No. 2010-01(S)

MODELS: 2009 Evinrude E-TEC 75-90 HP
Outboards

SUBJECT: Incorrect Wiring Diagram in Service
Manual, P/N 5007811

P/N 355362 – New wiring diagram

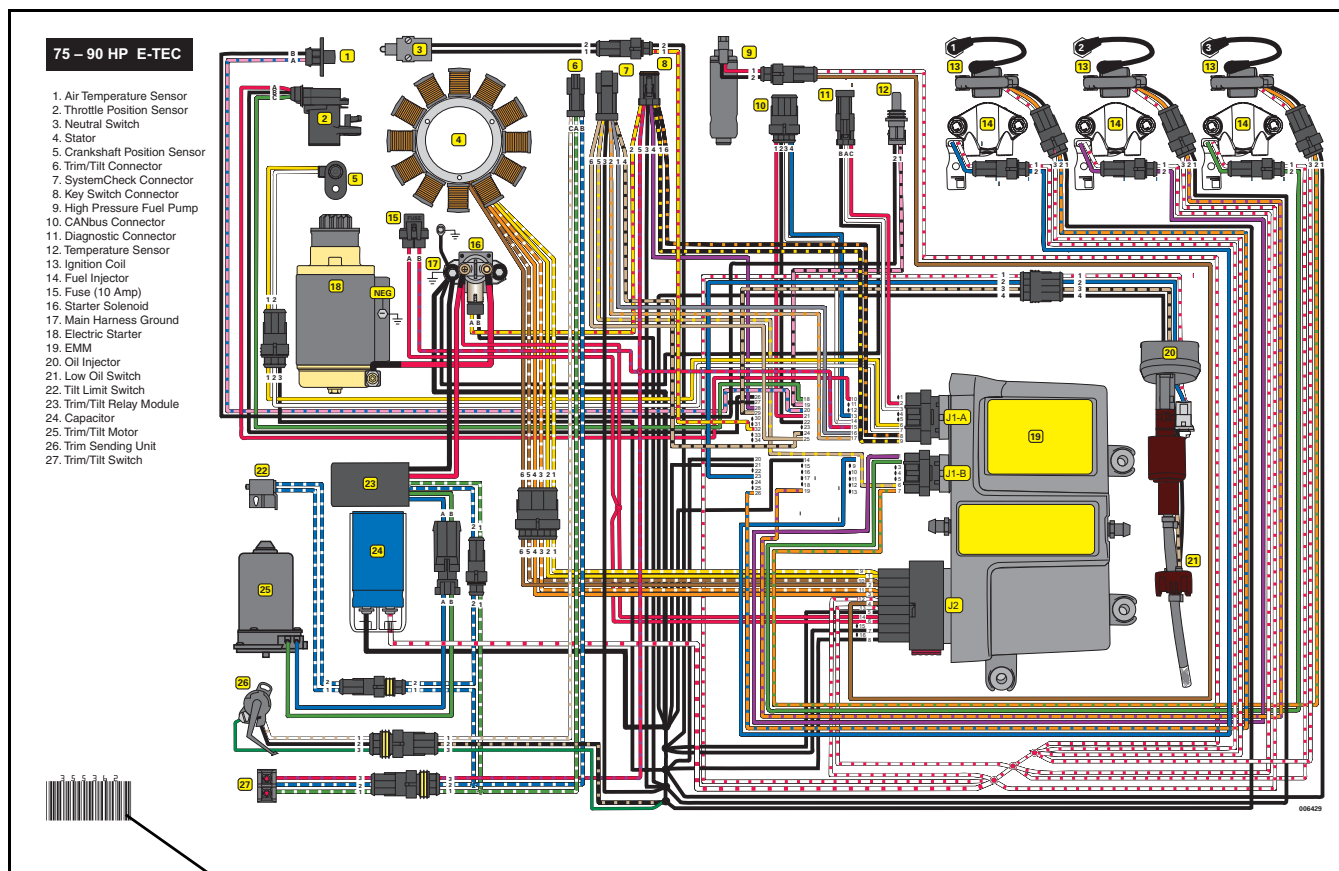
This communication is to inform Evinrude/Johnson dealers of an incorrect wiring diagram in the 2009 Evinrude E-TEC 75-90 HP Service Manual, P/N 5007811.

This “replacement” wiring diagram (included with this bulletin) should be attached to the original wiring diagram in the service manual. Dealers are asked to place the 2009 Evinrude E-TEC 75-90 HP wiring diagram, P/N 355362, in 2009 Evinrude E-TEC 75-90 HP Service Manual, P/N 5007811.
